## Application for Licence Amendment

<b>Licence Number</b>	L7276/1996/12
<b>Licence Holder</b>	Murrin Murrin Operations Pty Ltd
<b>ACN</b>	076 717 505
<b>File Number</b>	2011/011705-1
<b>Premises</b>	Murrin Murrin Nickel Cobalt Project  Mining tenements: L39/62, L39/81, L39/83, L39/136, L39/168, M39/299, M39/300, M39/301, M39/314, M39/322, M39/421, M39/422, M39/423, M39/435, M39/436, M39/424, M39/342, M39/343, M39/446, M39/553, M39/562, M39/637, M39/651, M39/686, M39/692, M39/714, M39/715, M39/716, M39/737, M39/820  LAVERTON WA 6440  As defined in Schedule 1 of the licence
<b>Date of Report</b>	29 November 2023
<b>Decision</b>	Revised licence granted

This Amendment Report documents the assessment of potential risks to the environment and public health from proposed changes to the emissions and discharges during operation of the Premises. As a result of this assessment, Revised Licence L7276/1996/12 has been granted.

**Figure 3: Paddock TSF, evaporation ponds and groundwater monitoring locations**

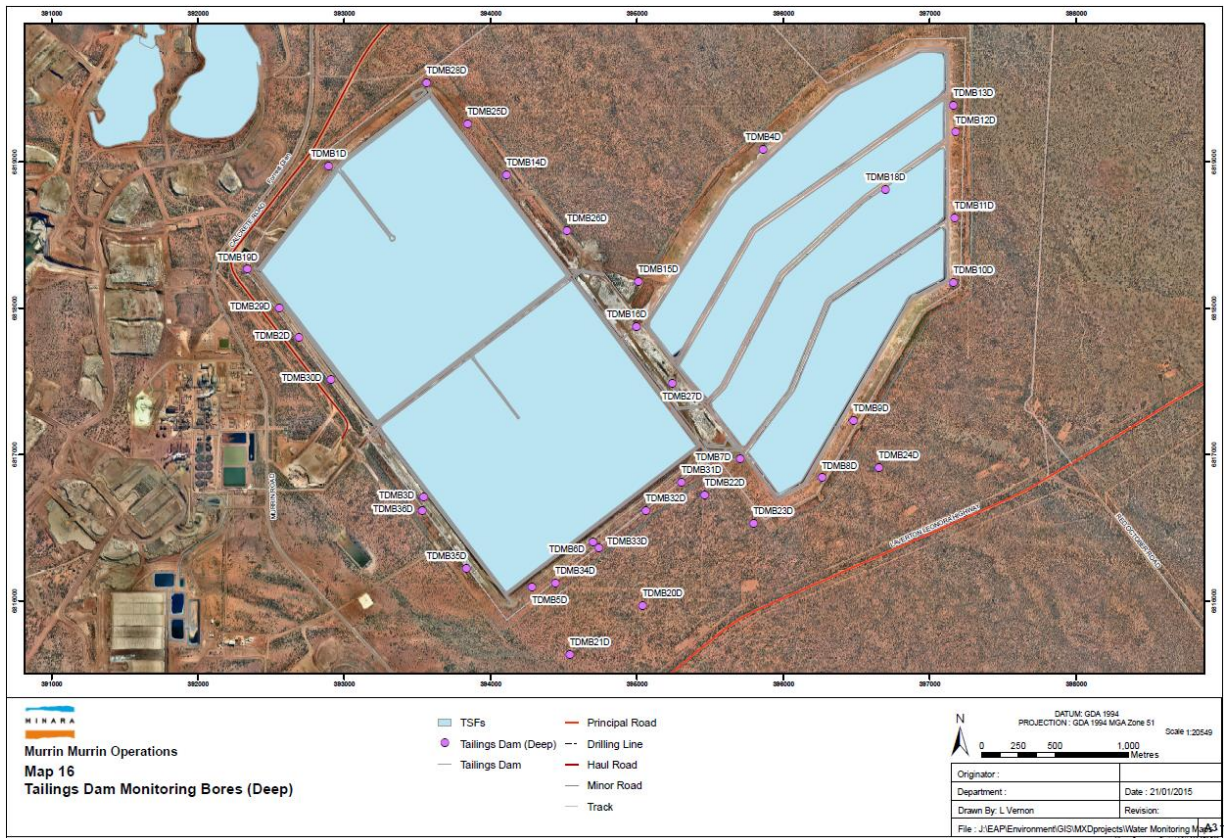
The Licence Holder has requested a reduction of required monitoring surrounding the paddock TSF from quarterly to biannually. The following justification for the proposed amendment has been provided by the Licence Holder:

- Both paddock TSF cells are decommissioned, and the last discharge of tailings occurred in 2015;
- Groundwater levels have been steadily falling over the past five years and pH is steady and close to neutral;
- TDS is mostly steady with exception to monitoring bores situated closer to the TSF and evaporation ponds; and
- The Licence Holder seeks to prioritise monitoring resources towards active in-pit TSFs and higher risk areas.

3.5.2	Added condition requiring the Licence Holder to conduct quarterly groundwater monitoring for two annual periods surrounding the paddock TSF if authorised discharge occurs.

**Figure 9: Source and Discharge Pits located at Murrin Murrin East**

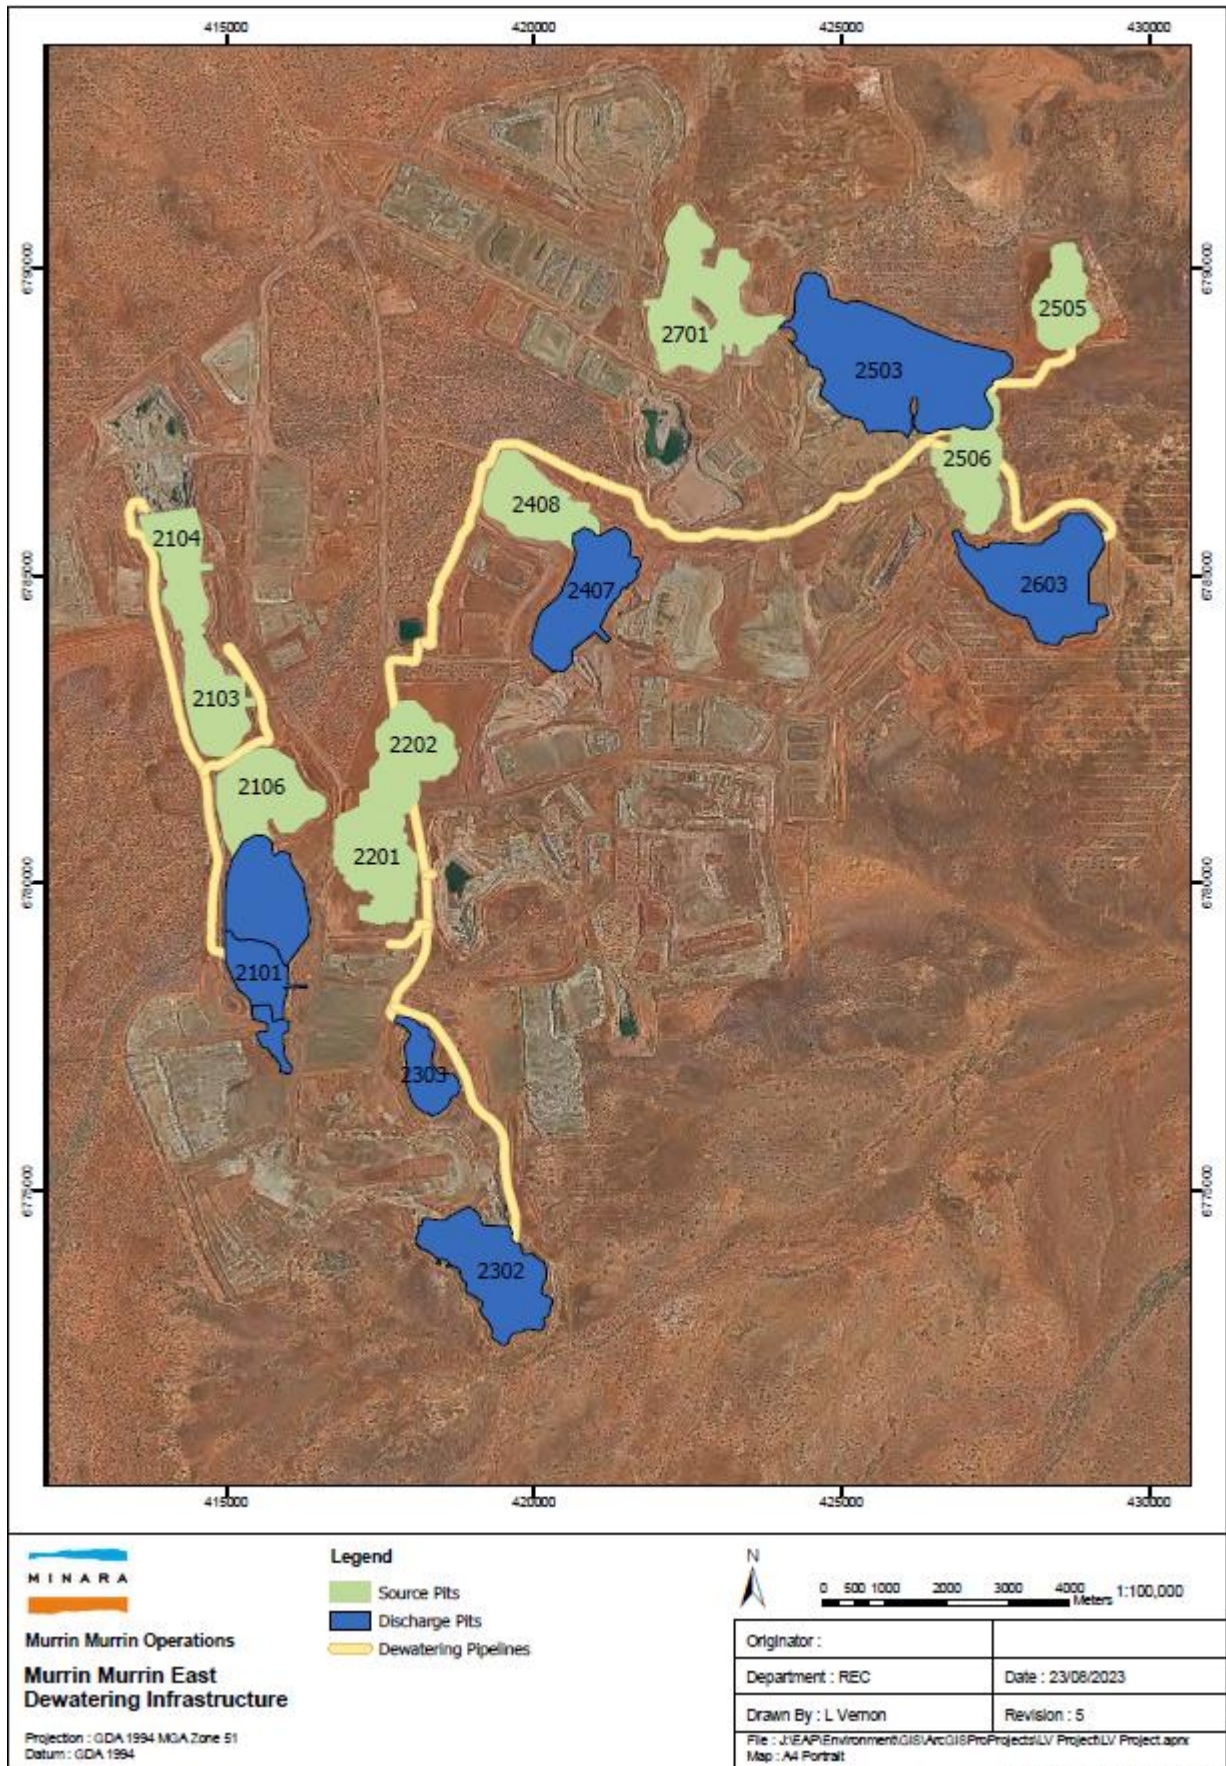
The Licence Holder has also requested Pits 2407 and 2503 be added to this licence as additional mine dewater discharge locations as presented in Figure 9. Pits 2402 and 2502 have been backfilled and have been removed from the Licence as part of this amendment. Pit 2704 has not been developed as a Pit and there is no short to medium term plans for the proposed pit and therefore has also been removed from the Licence.

To develop the risk assessment for the amendment, on 25 August 2023 the Licence Holder (at the request of the Department) provided the pit details and capacity of all current and proposed discharge pits as presented in Table 2.

1.3.13	Removed discharge pits 2402, 2502 and 2704 from Table 1.3.6 and inserted pits 2407 and 2503.
1.3.14	Corrected out crest heights and estimated volumes for pits 18/3 and 18/6.

**Figure 15: SO<sub>2</sub> emissions based on two years monitoring data conducted as part of the Licence requirement.**

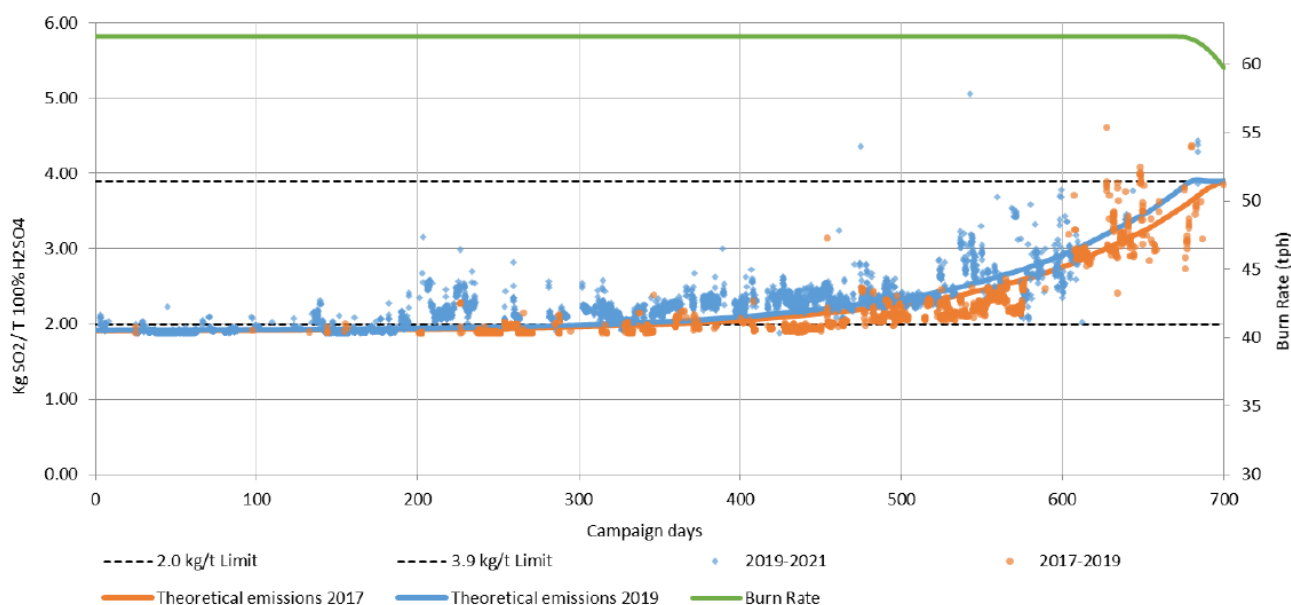
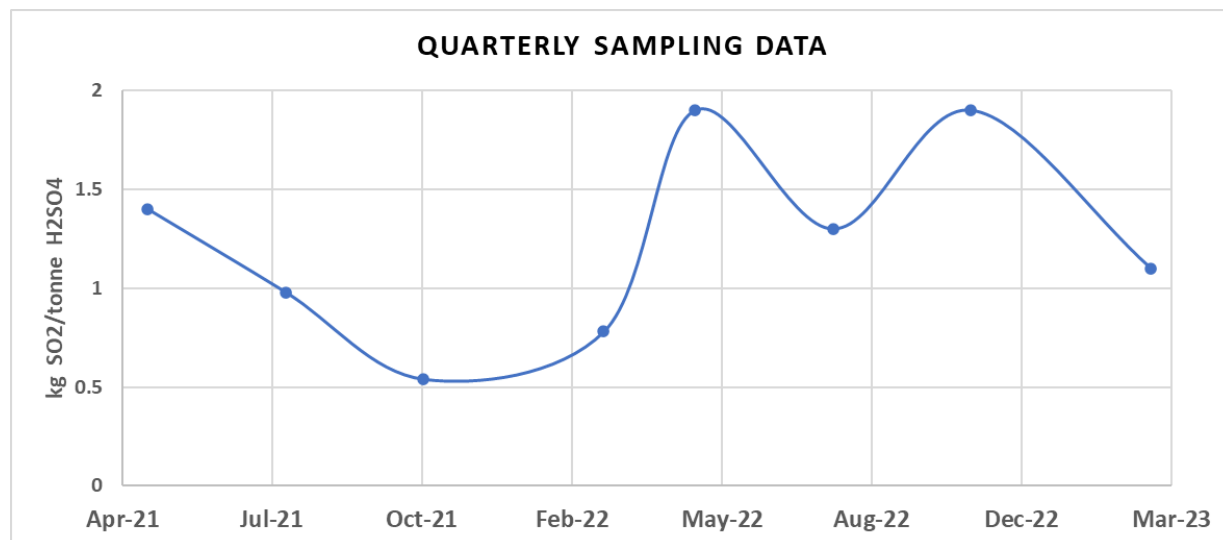
Based on a theoretical prediction of SO<sub>2</sub> emissions provided, it is anticipated by the licence holder that the SAP will operate at the higher emission output for short periods of time and SO<sub>2</sub> emissions would not exceed 2 kg/t H<sub>2</sub>SO<sub>4</sub> until approximately a year into the biennial catalyst campaign life, and that operation at the 3.9 kg SO<sub>2</sub>/t H<sub>2</sub>SO<sub>4</sub> limit will only occur in the final stages of the campaign, that is, from day 600 onwards. The theoretical emissions curve is reproduced in Figure 11.

However, analysis carried out by DWER, of SO<sub>2</sub> stack testing data for a similar period (two years of monitoring data measured as required by licence) indicates that the SAP SO<sub>2</sub> emission pattern is different from the theoretical emissions curve provided by the applicant (Figures 11 and Figure 15). For example, according to Figure 15, the SO<sub>2</sub> emission can rapidly vary from minimum to the highest levels (Licence limit) and vice versa. Therefore, DWER cannot verify whether theoretical predictions provided by the licence holder for SO<sub>2</sub> emissions is valid.

DWER understands that catalyst screening requires collecting samples for chemical analysis. Based on the activity of the catalyst measured and the stack emission levels of SO<sub>2</sub>, the length of time that the plant can continuously operate and the amount of catalyst which needs to be replaced in the next shut down can be estimated. It is recommended that catalyst screening information is provided to the department to verify the assumptions made and to inform future regulatory controls.

It is recommended that the licence holder is required to verify the emissions assumptions on an ongoing basis by providing catalyst performance data to complement stack testing data.

A requirement to include the collection of sampling data for the SAP catalyst screening under condition 3.1.3 has been added to the licence. Condition 4.2.2 has also been updated to require the Annual Environmental Report to include an assessment of the SO<sub>2</sub> monitoring data for the SAP plant and the sampling data for the catalyst screening to be undertaken against the assumptions made within the *Murrin Murrin Sulphuric Acid Plant – Air Quality Assessment, by Environmental Technologies & Analytics, August 2022.*

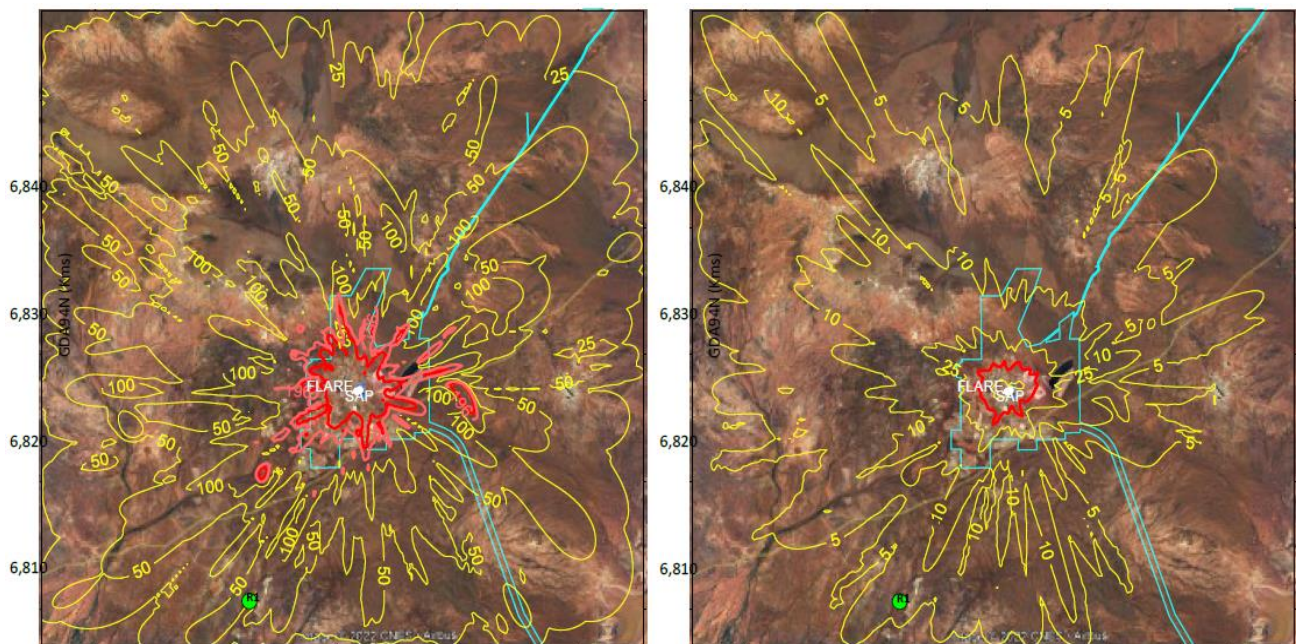
Under the new proposed normal operations (non-cold start-up) ETA's air emission assessment concluded that:

- The 1-hour ground-level SO<sub>2</sub> concentration remained below the current and future assessment criteria for the Minara Homestead.
- The 24-hour ground-level SO<sub>2</sub> are predicted to increase but remain below the assessment criteria for the Minara Homestead.
- The predicted GLCs at Minara Homestead were reported below the adopted assessment criteria during the 1-hour exposure concentrations.
- Air Quality Guidelines were exceeded both within and offsite of the Prescribed Premises for the future NEPM criteria.
- Air Quality Guidelines were only exceeded within the Prescribed Premises for the current NEPM criteria.

**Figure 15: Summary of predicted SO<sub>2</sub> concentrations ( $\mu\text{g}/\text{m}^3$ ) at Minara Homestead (R1) (ETA 2022).**

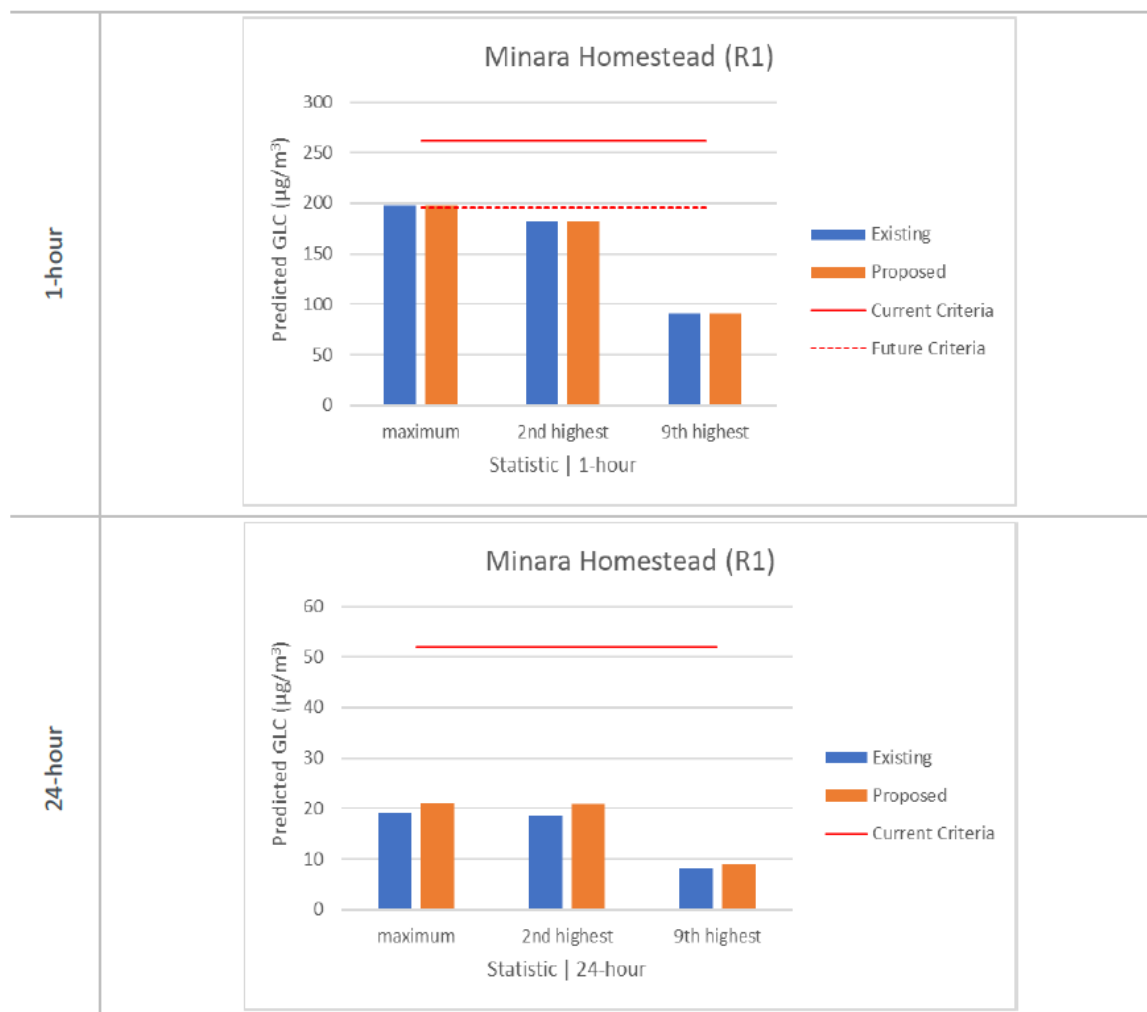
Predicted GLCs of SO<sub>2</sub> results during a cold start proposed scenario are presented in Figure

15. The main observations and summaries are relating to prediction cold start-ups are:

- At the maximum emission GLCs are predicted to be below the current 1-hour assessment criteria ( $262 \mu\text{g}/\text{m}^3$ ) and marginally above the future NEPM assessment criteria ( $196 \mu\text{g}/\text{m}^3$ ).
- At the second highest emission GLCs are predicted to be below both current and future NEPM assessment criteria.
- At the maximum emission GLCs are predicted to be below the 24-hour NEPM assessment criteria.

- The maximum predicted SO<sub>2</sub> concentrations are 76% and 101% of the current and future (2025) NEPM 1-hour criteria respectively for start-up operating conditions, noting that start-up emissions were modelled as if they occur continuously.

As discussed above, based on DWER's understanding that start-up operations occur over a few hours several times per year, these results do not represent a significant risk at the closest sensitive receptor location.
